भारत सरकार - रेल मंत्रालय
अनुसंधान अभिकल्प और मानक संगठन
लखनऊ - 226011
Government of India - Ministry of Railways
Research, Designs & Standards Organization,
LUCKNOW - 226011

MODIFICATION SHEET NO. RDSO/2009/EL/MS/0386 Rev '1'**Dated: 29.10.2012**

Modification in loco control circuit for multiple unit operation (MU) max. for three locos for 25 kv ac electric locomotive working with microprocessor based control and fault diagnostic system (MPCS) as per RDSO's specification. No. ELRS/SPEC/MPC-FDS/0001 Rev-'2'- August 2005 (ver-2)

Auto-regression circuit for Consist/MU loco operation

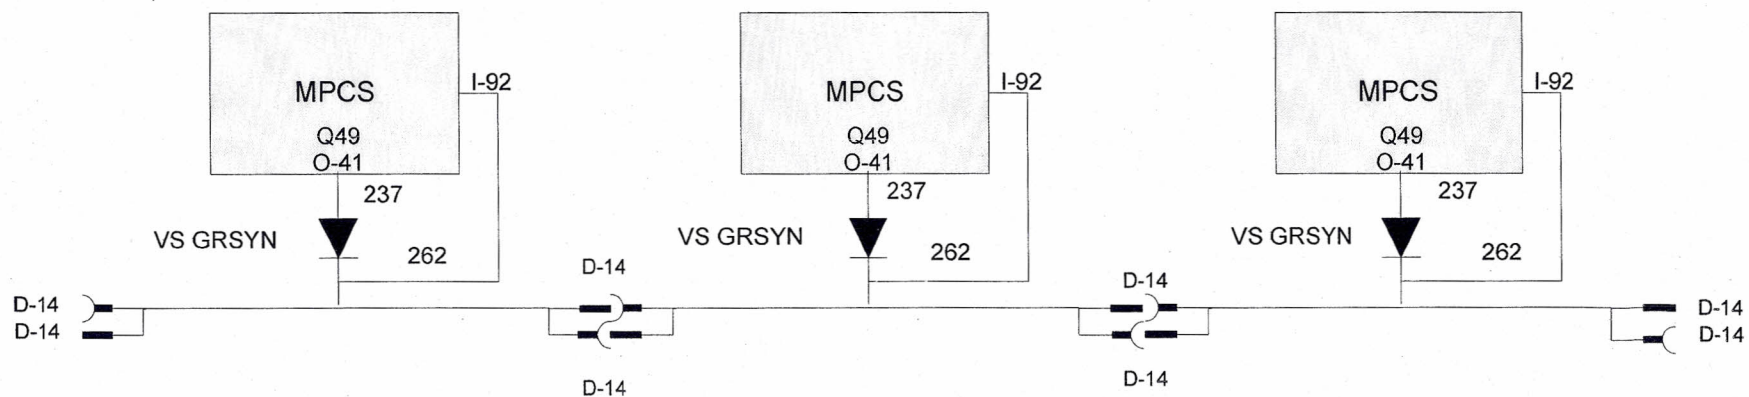
- b) Output of O-40 for Q51 (Wire no.259) should be connected through a VS – AU REG to input no. I-84 (wire no. 261) of the same loco. Wire no. 261 should be connected to MU jumper no. D15 as per Annexure - A.

Synchronization circuit for Consist/MU loco operation

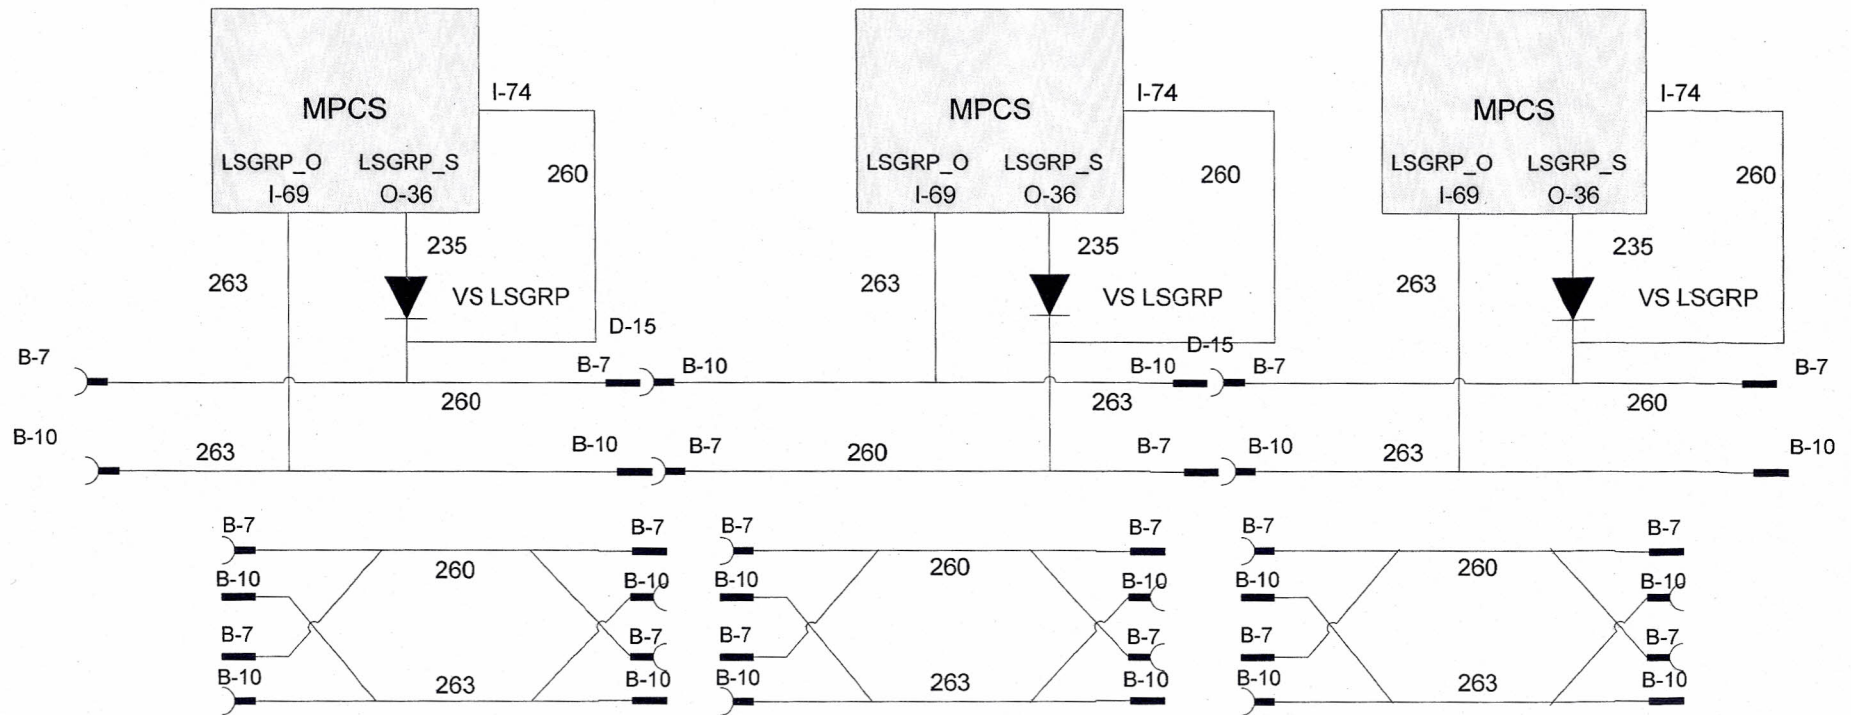
- a) Output of O-41 for Q49 (Wire no.237) should be connected through a VS – GR SYN to input no. I-92 (wire no. 262) of the same loco. Wire no. 262 should be connected to MU jumper no. D14 as per Annexure - A.

LSOL fault locator circuit for MU loco operation

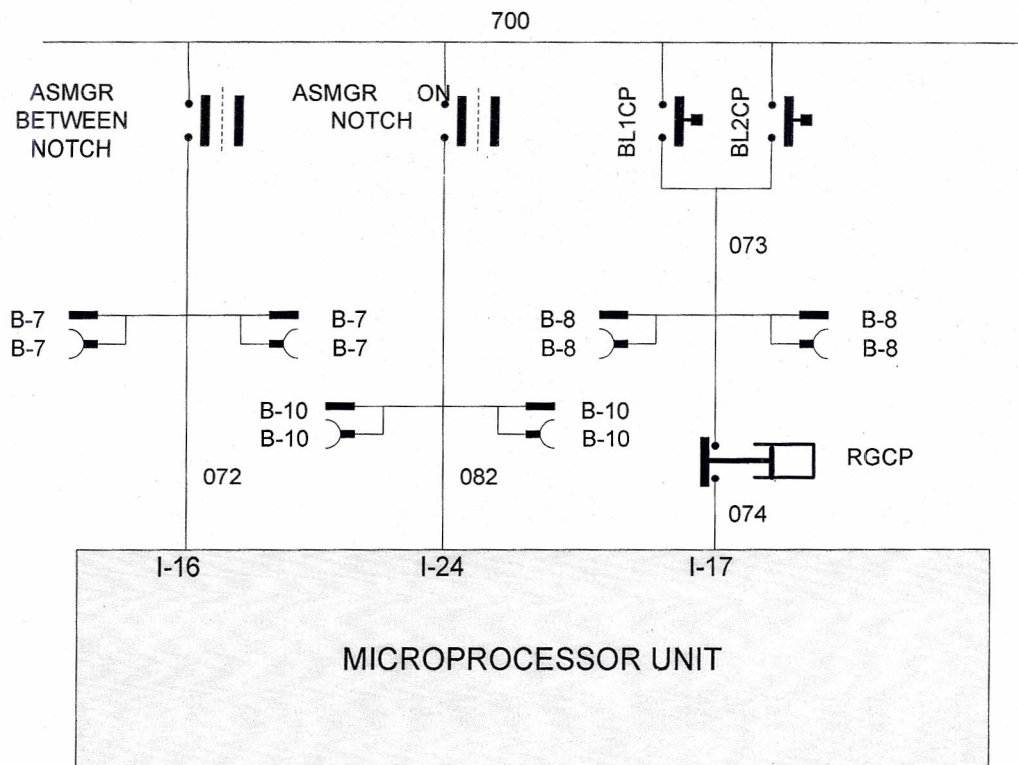
- a) A new MU jumper no. C13 will be used for VESAs coil of sanding circuit as show in annexure-D. Two diodes (VS 20) are to be used to protect MPCS output O-23 and O-25.
- b) Two MU jumper no. B-7 & B-10 and one input I-74 through a diode VS LSGRP will be used for LSOL signaling lamp for fault indication in trailing loco in MU operation. LSOL lamp output will be fed according to the software logic as shown in annexure- B.
- c) Output of O-36 for LSGRP_S (Wire no. 235) should be connected through diode VS –LSGRP to input no. I-74 (wire no. 260) of the same loco. Wire no. 260 should be connected to MU jumper no. B-7. One Input I-69 (wire no. 263) will be connected to MU jumper no. B-10 in cross connection with B-7 as per annexure B.

Note:- Modification in software for LSOL (O-37) lamp logic to be done by manufacturer as given below

Output O-37 of LSOL lamp = [(I-69 OR I-74) AND O-36]

Annexure- C

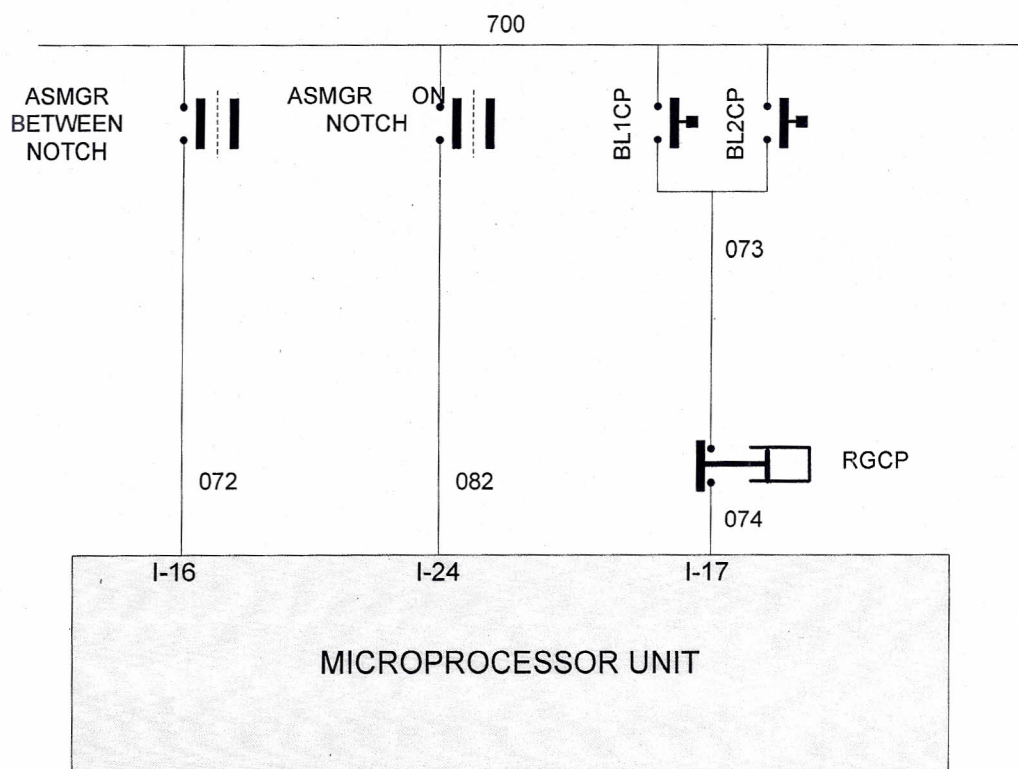
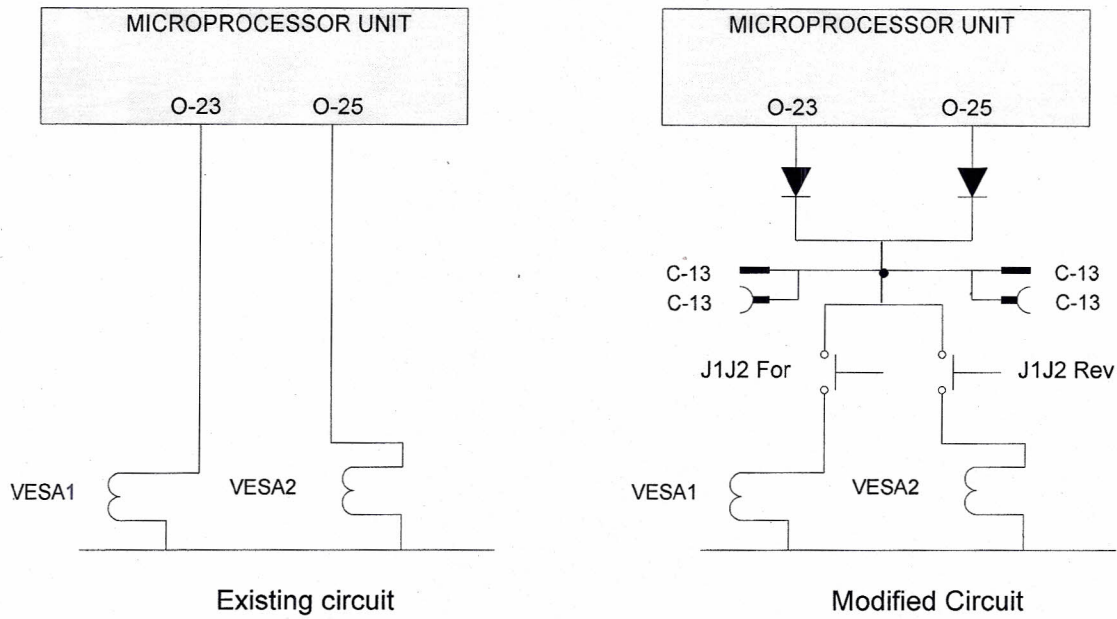
- a) Since relays Q49 and Q52 are eliminated in MPCS, the ASMGR BN (I-16) and ASMGR ON (I-24) are not required in case of MU operation. So there is no need of extension of these signals to MU coupler.
- b) MU jumper no. B-7 from wire no. 072 of ASMGR (BN) used for I-16.
- c) MU jumper no. B-10 from wire no. 082 of ASMGR (ON) used for I-24.
- d) MU jumper no. B-8 from wire no. 073 of BLCP used through RGCP for I-17. This wire is required to be removed to take care of the auto cut OFF of compressors of rear locomotives from leading locomotive.
